nationalgrid	DISTRIBUTION PLANNING DOCUMENT	Doc. RI-26012283
	Interconnection Study	Page 1 of 40
	Complex Generating Facility – RIPUC 2180	Version 1.0 8/16/2014
	EXETER RENEWABLES 1 LLC 10,000 kW / kVA AC, Inverter-Based Photovoltaic 89 TEN-ROD RD EXETER, RI	DRAFT

System Impact Study for Distributed Generation Interconnection to National Grid’s 34.5 kV System

DG WR: RI-26012283
Applicant: EXETER RENEWABLES 1 LLC
Address: 89 TEN-ROD RD
City: EXETER
DG kW/kVA: 10,000 kW and 10,000 kVA
DG Type: Inverter-Based Photovoltaic
Feeder: Wickford Junction 30T1

Figure B- 1: PCC Configuration

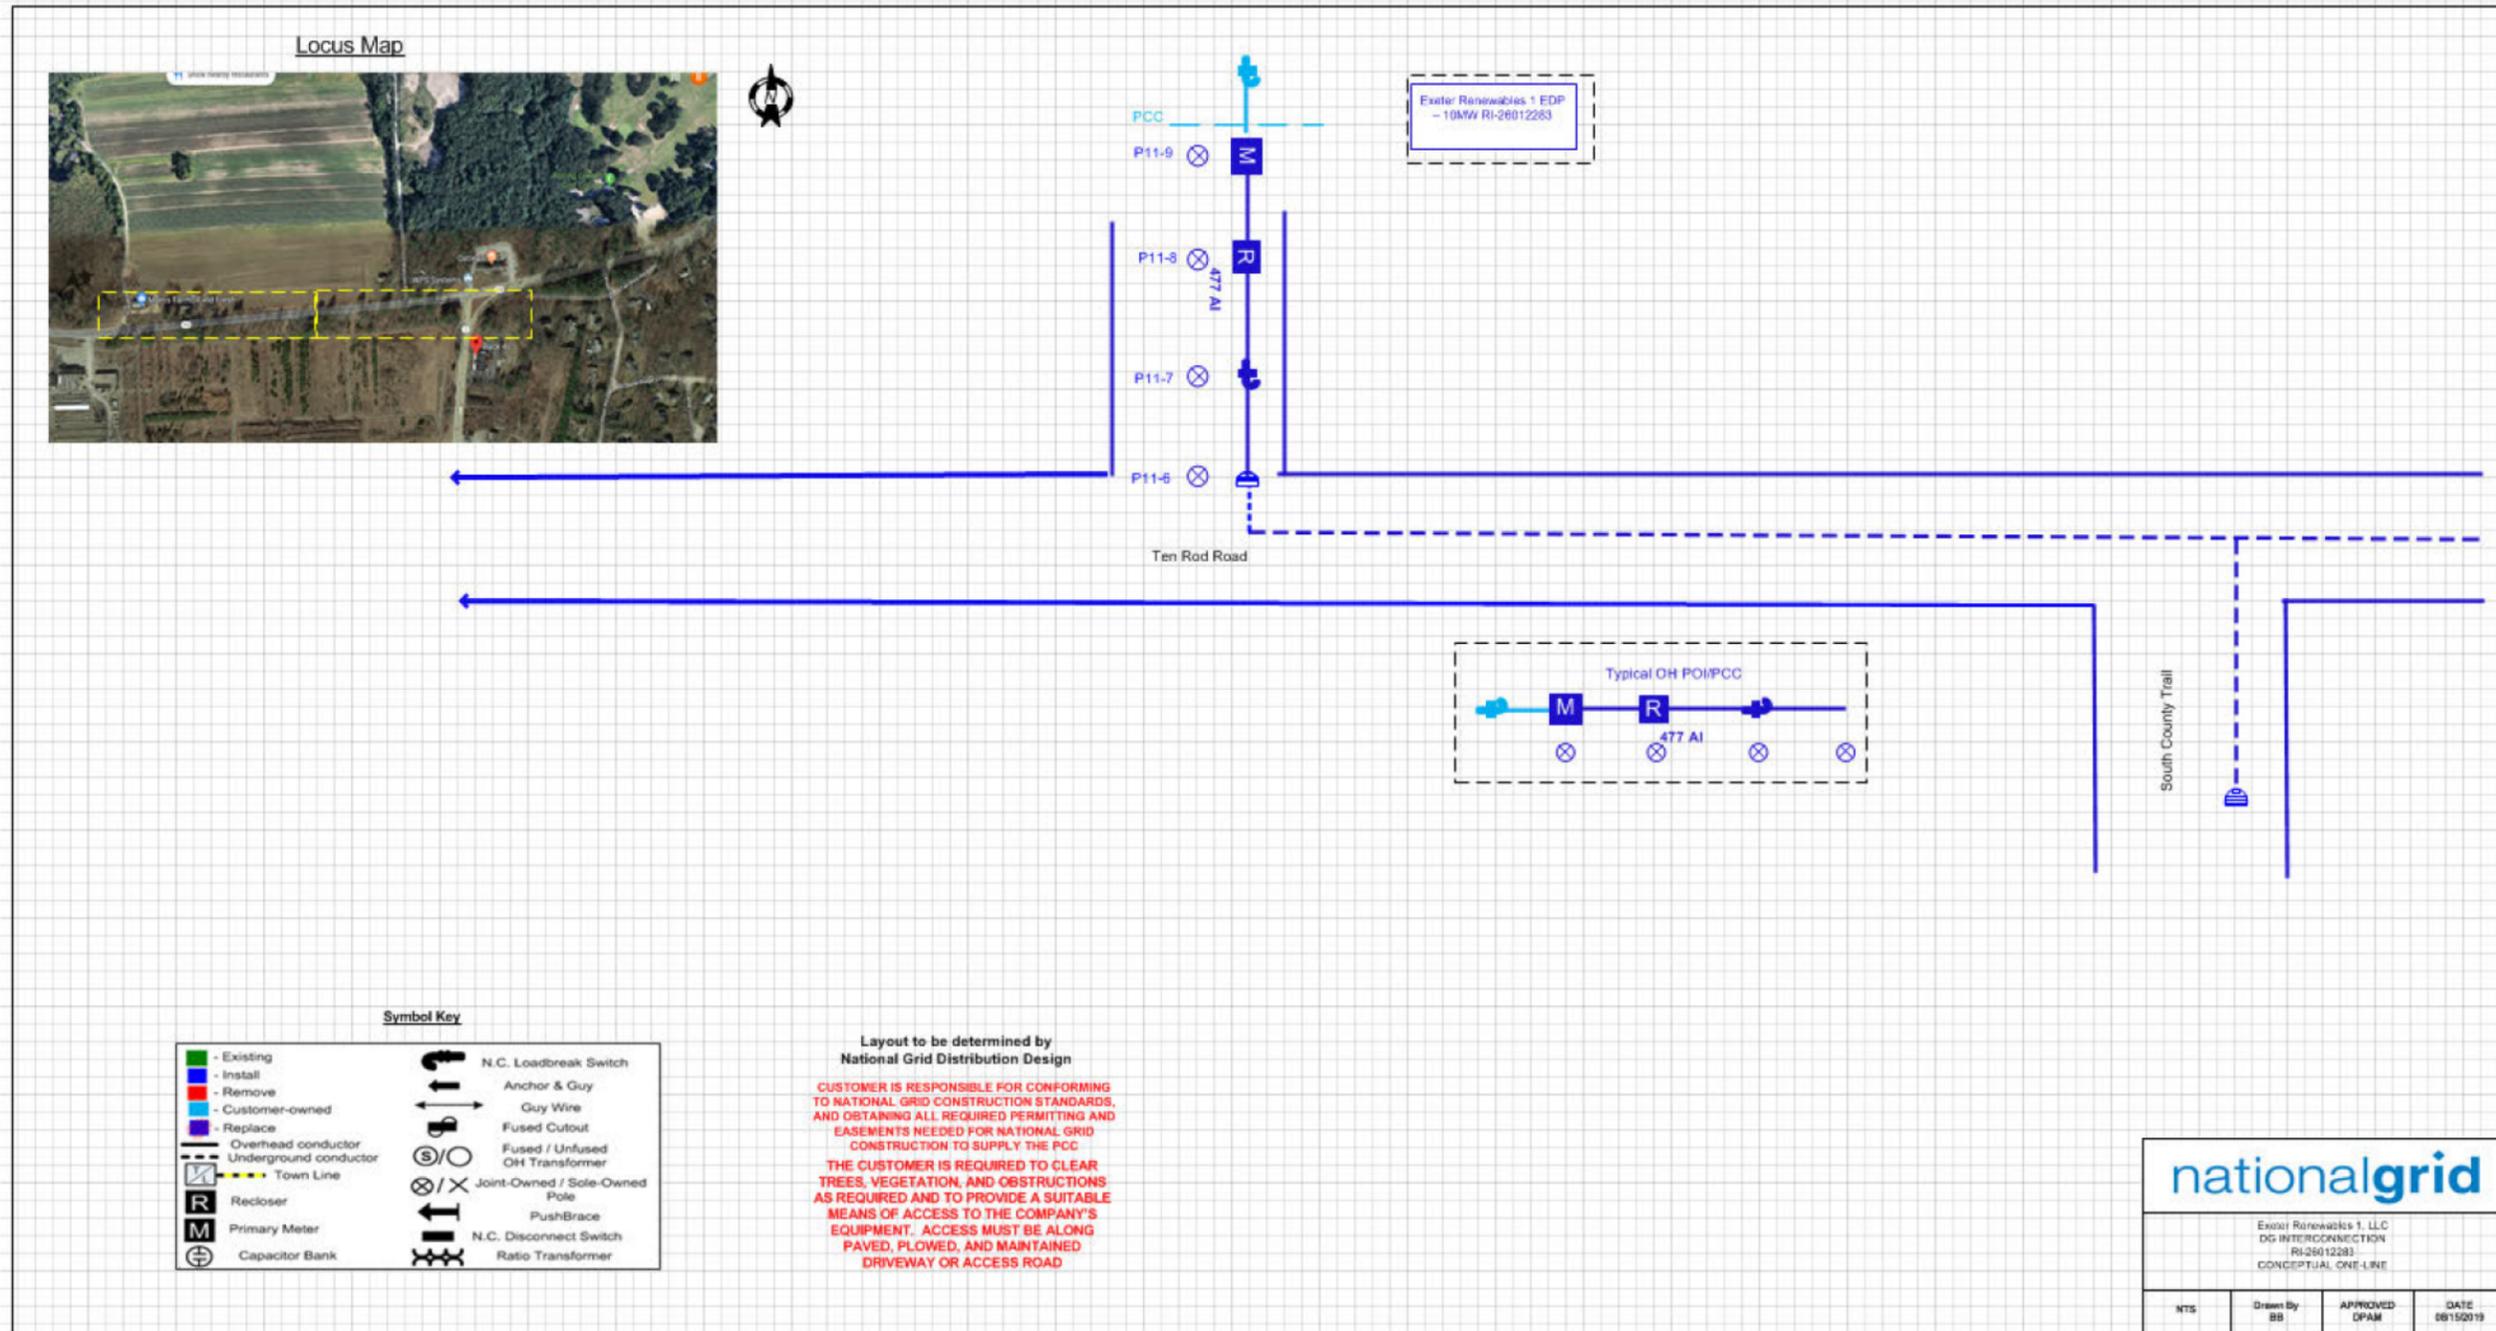
6. Installation of a three-phase disconnect switch on proposed Pole #11-7 Ten Rod Road (Figure B-1).

7. Installation of a recloser on proposed pole #11-8 Ten Rod Road (Figure B-1).
8. Install a primary meter on proposed pole #11-9 Ten Rod Road (Figure B-1)
